TECHNICAL MANUAL

POWER SUPPLIES PP-281/GRC, PP-281A/GRC, PP-282/GRC, PP-282A/GRC, AND PP-448/GR

TM 11-5040
CHANGES No. 2

HEADQUARTERS,
DEPARTMENT OF THE ARMY
WASHINGTON 25, D. C., 19 February 1958

Figure 3.1 (Added) Power Supplies PP-281A/GRC and PP-282A/GRC, top of chassis.

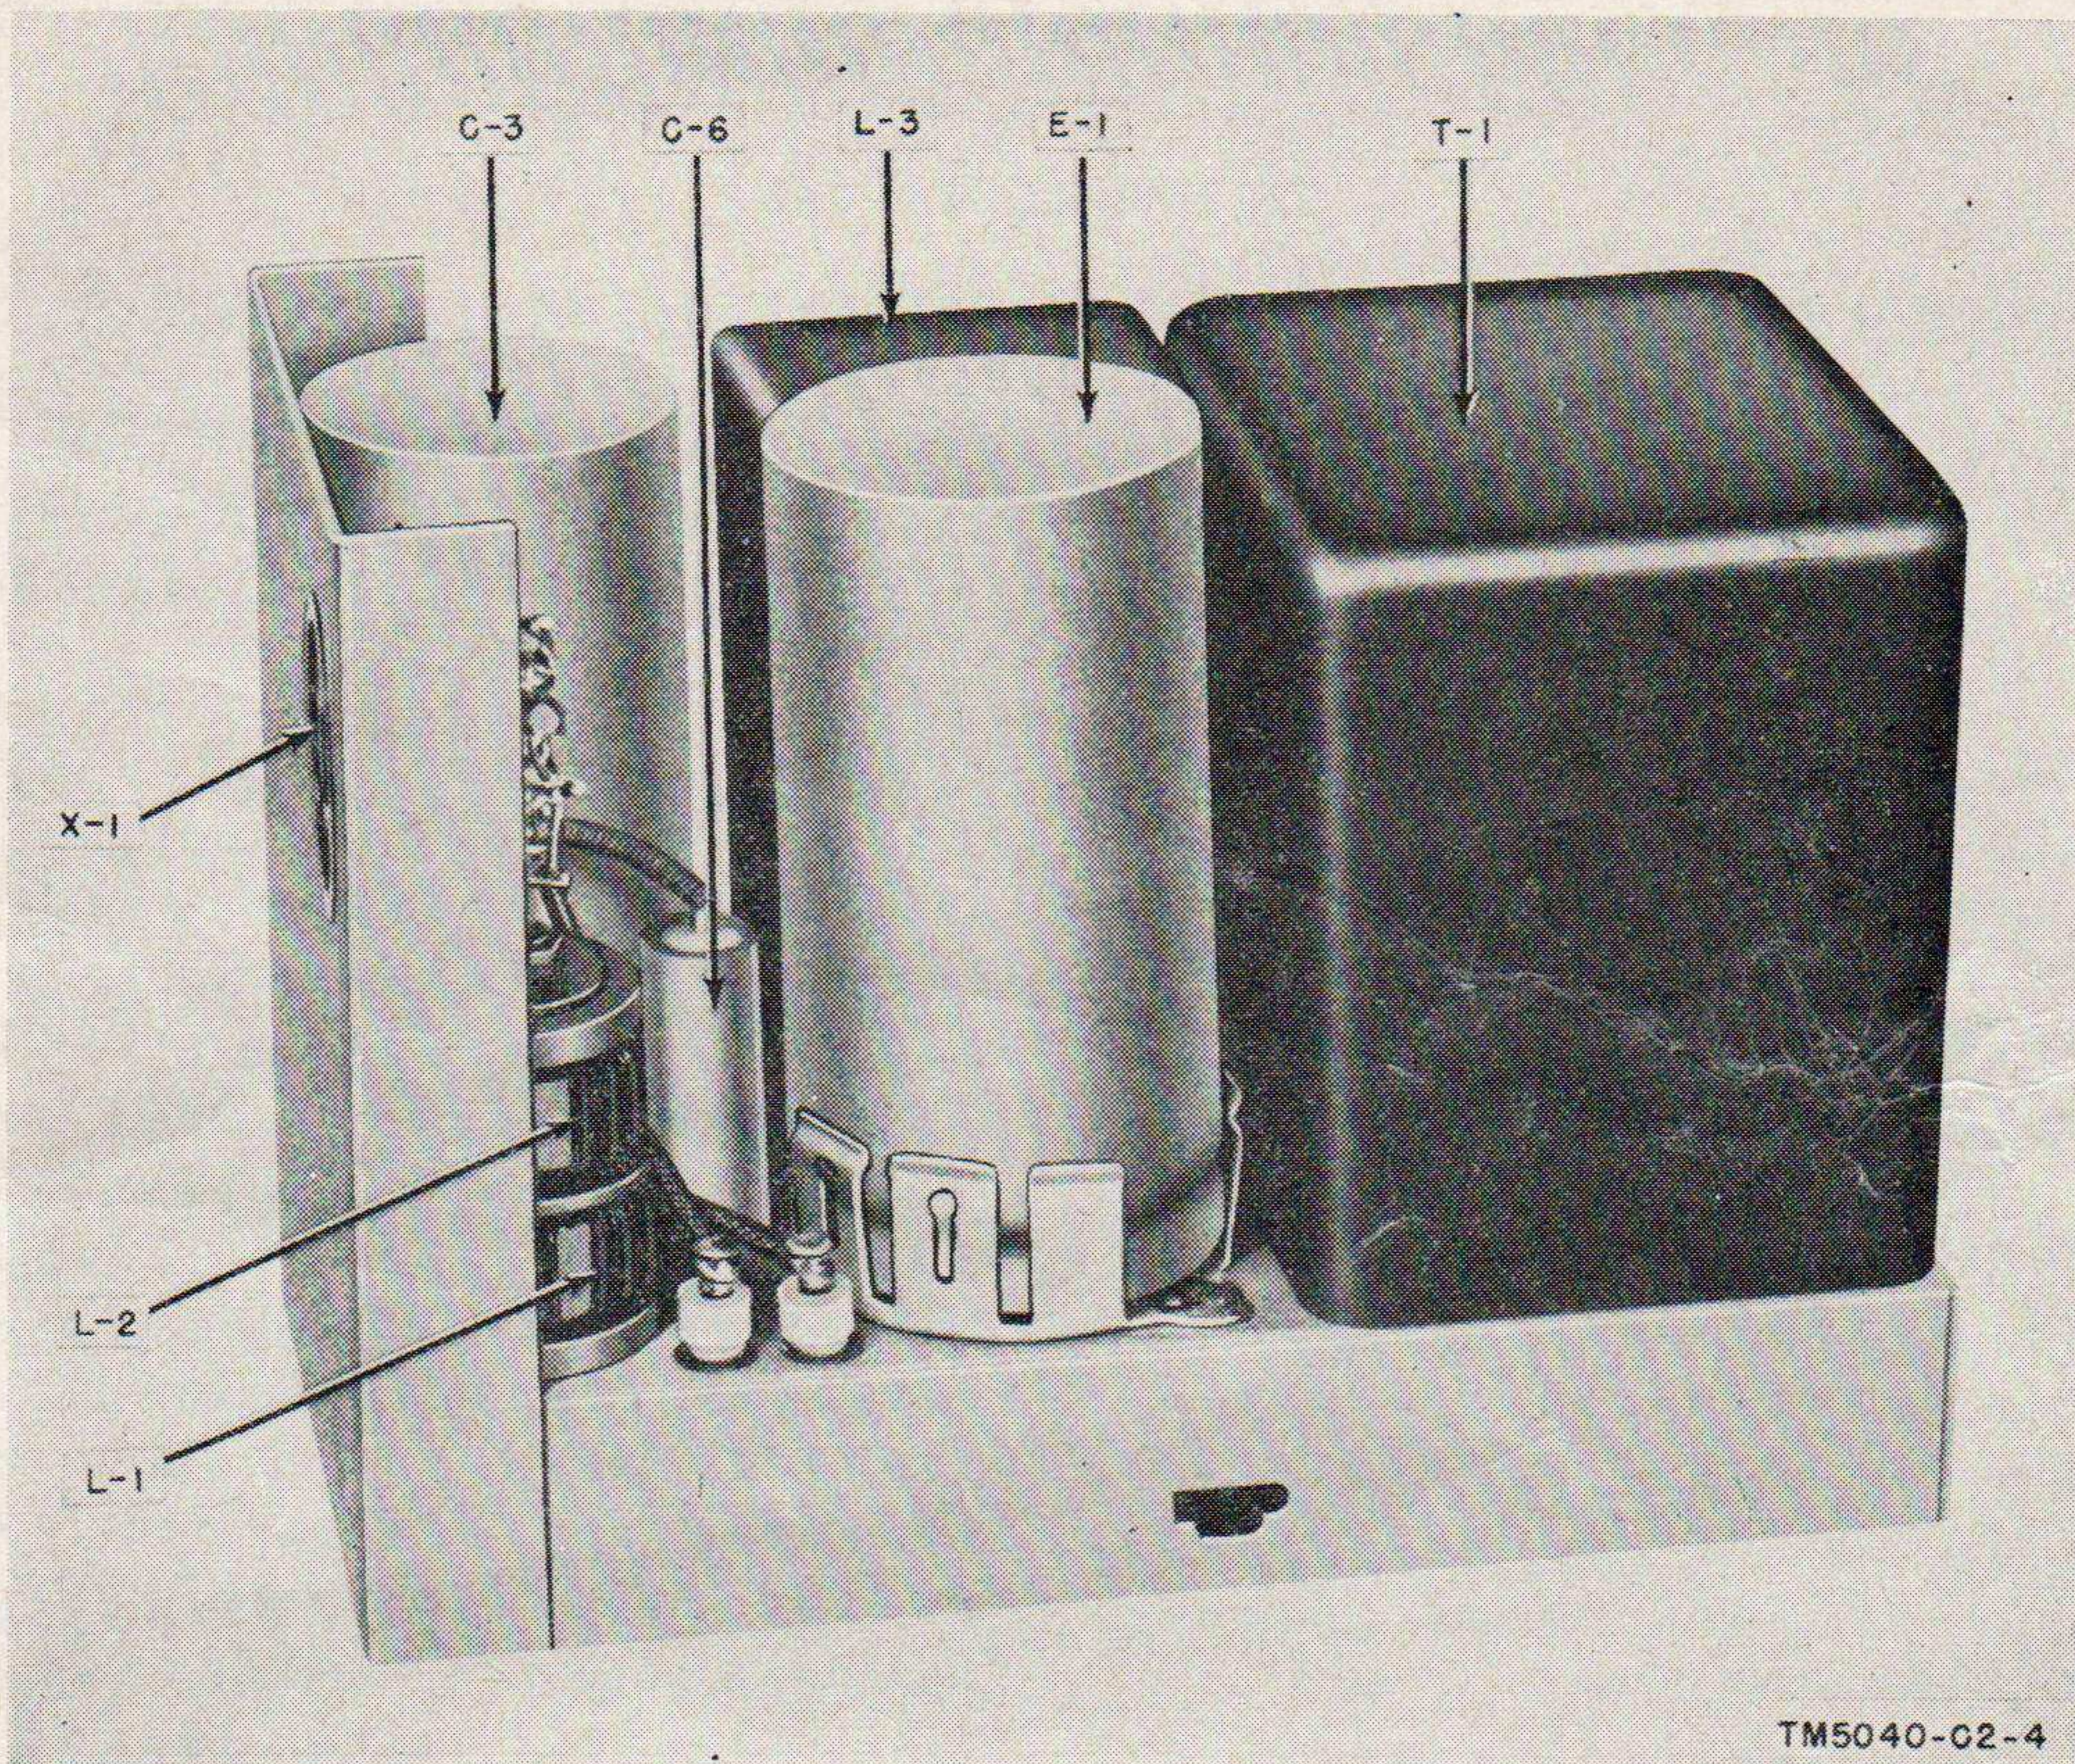
b. Design differences exist between Power Supply PP-281/GRC and Power Supply PP-281A/GRC; also between Power Supply PP-282/GRC and Power Supply PP-282A/GRC. The chart below lists the differences.

Component	Power Supply PP-281/GRC	Power Supply PP-281A/GRC	Power Supply PP-282/GRC	Power Supply PP-282A/GRC
C1	5,000 $\mu\mu\text{f}$	10,000 $\mu\mu\text{f}$	5,000 $\mu\mu\text{f}$	10,000 $\mu\mu\text{f}$
C5	Not present	1 μf	1 μf	1 μf
C6	Not present	39 μf	Not present	39 μf
R4	20 ohms	Not present	Not present	Not present
Wire to term. 4 of X-3	Yes	Not present	Yes	Not present

Figure 4.1 (Added) Power Supplies PP-281A/GRC, under chassis.

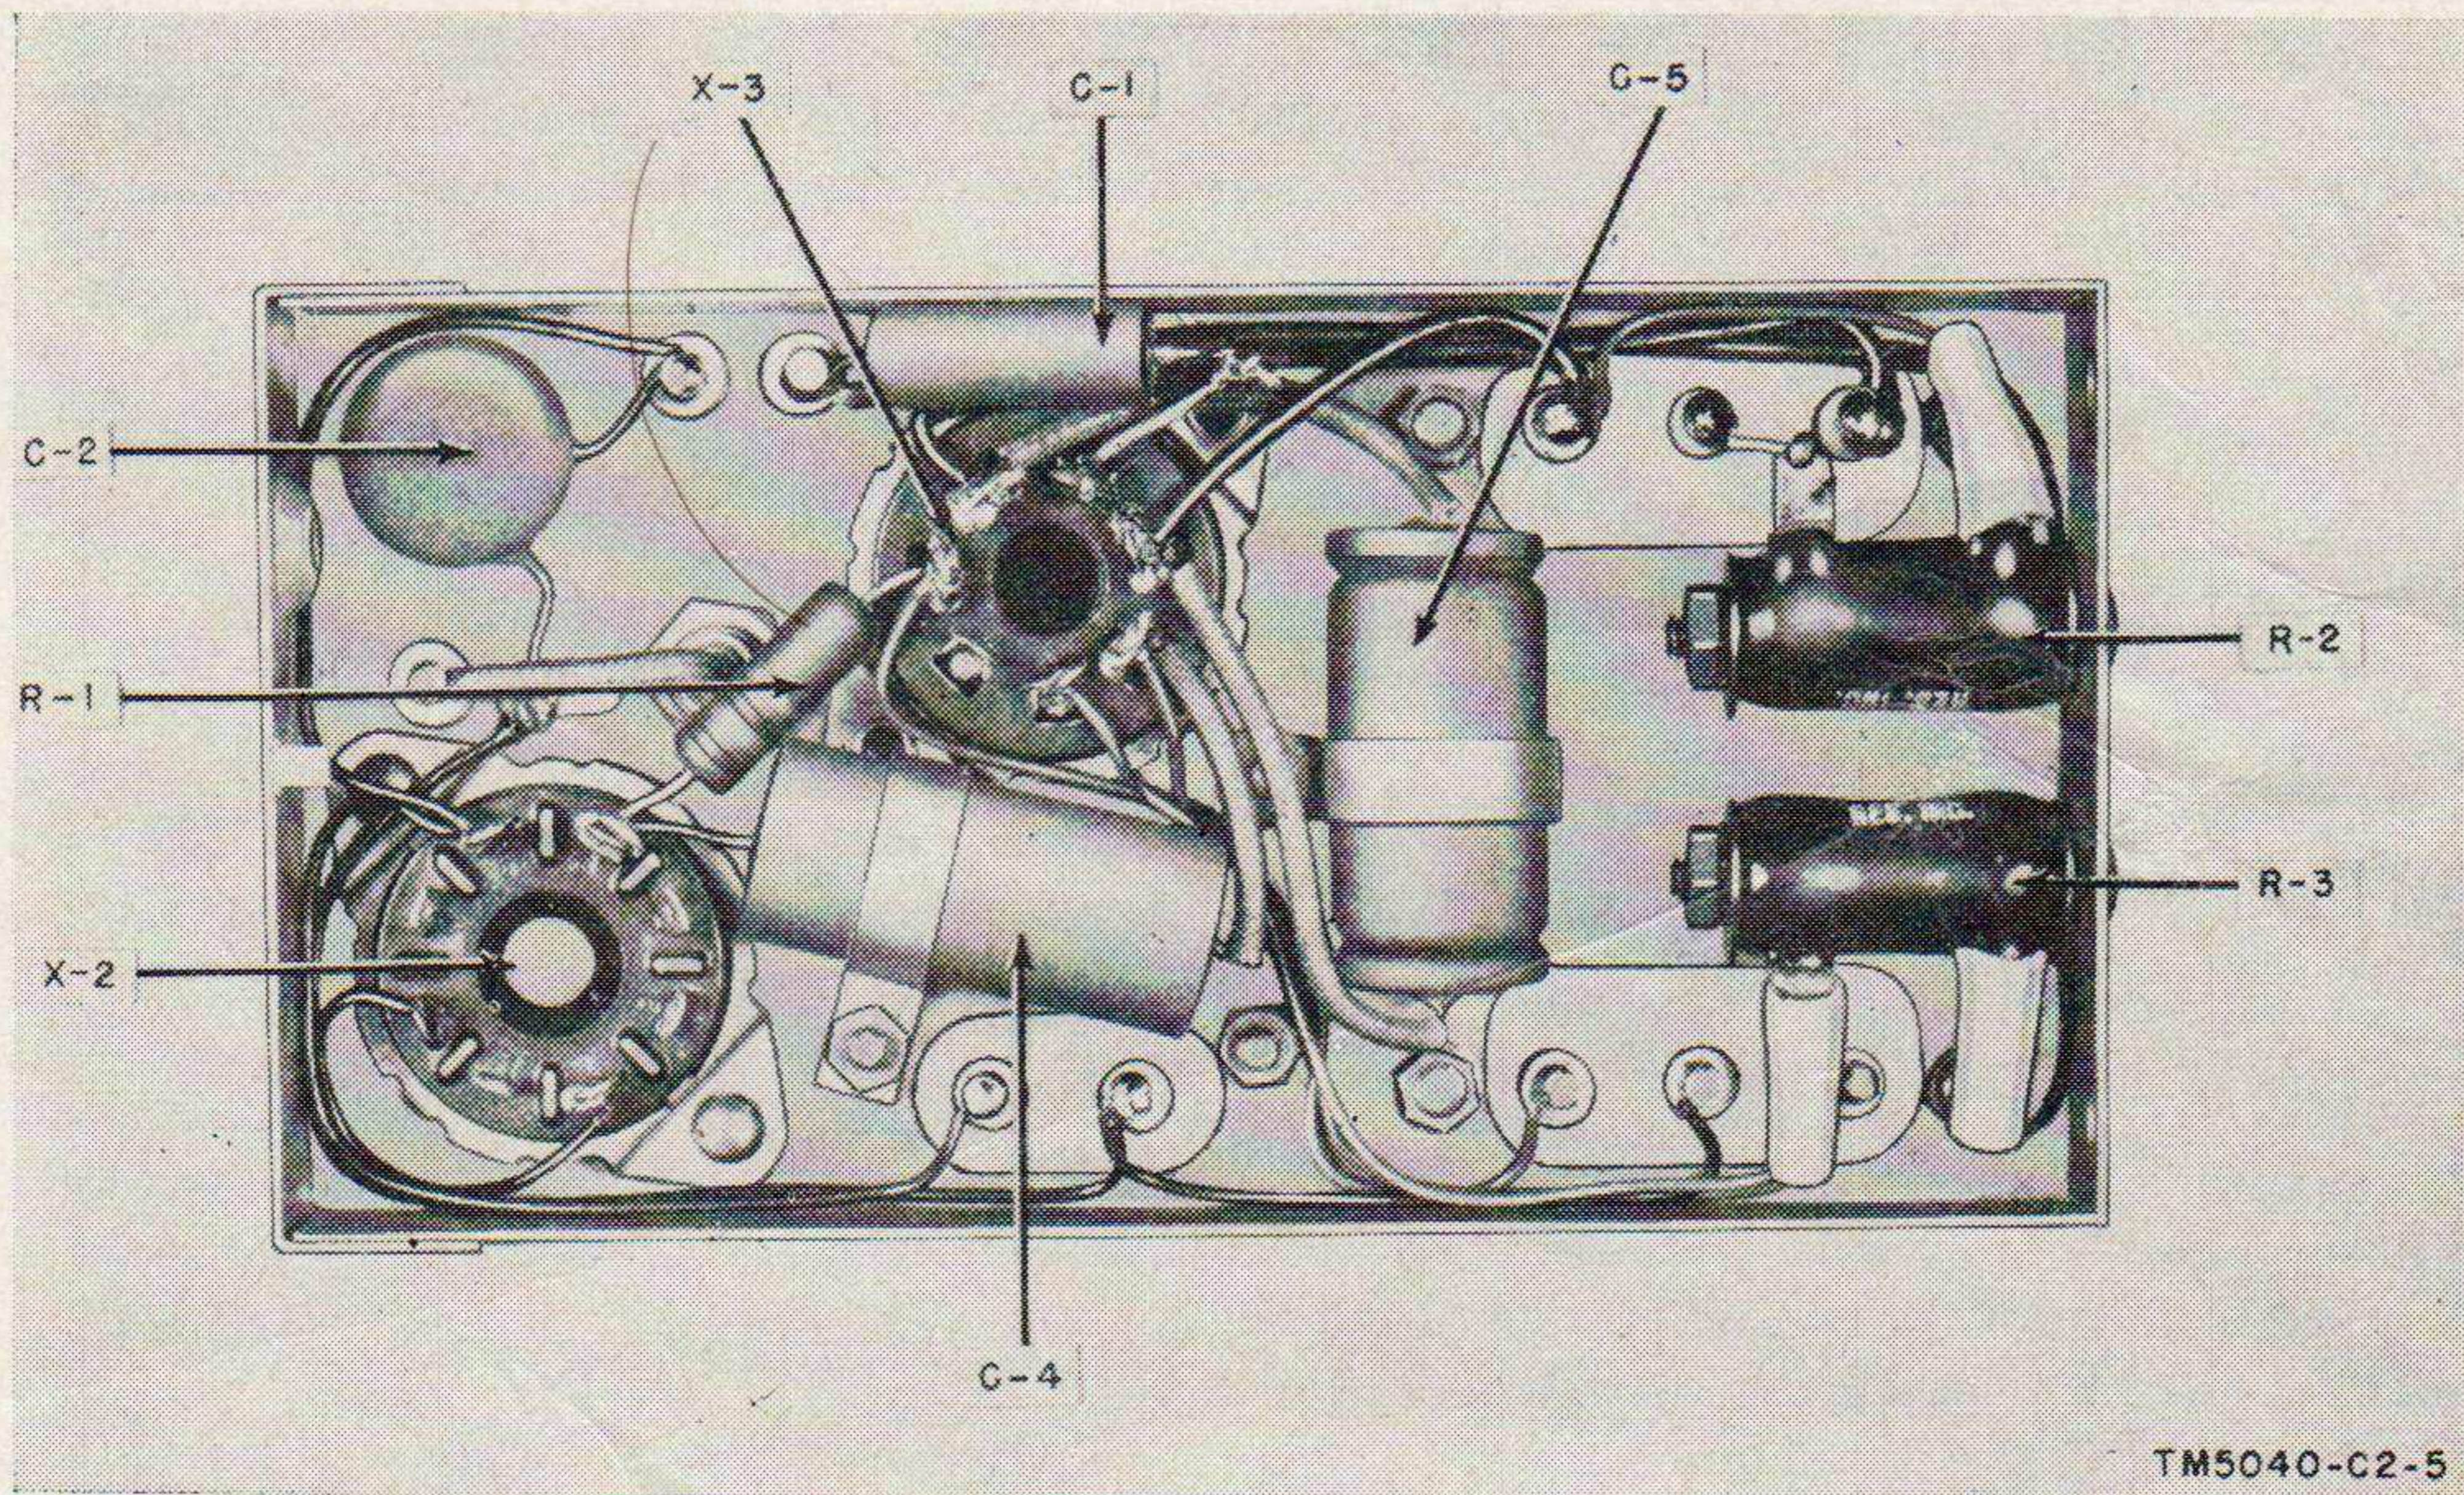
Note. Resistor R4 is not included in power supplies procured on Order No. 42913-Phila-57.

Note. Capacitor C5 is used in power supplies procured on Order No. 42913-Phila-57; accordingly, the second sentence in the above paragraph does not apply.
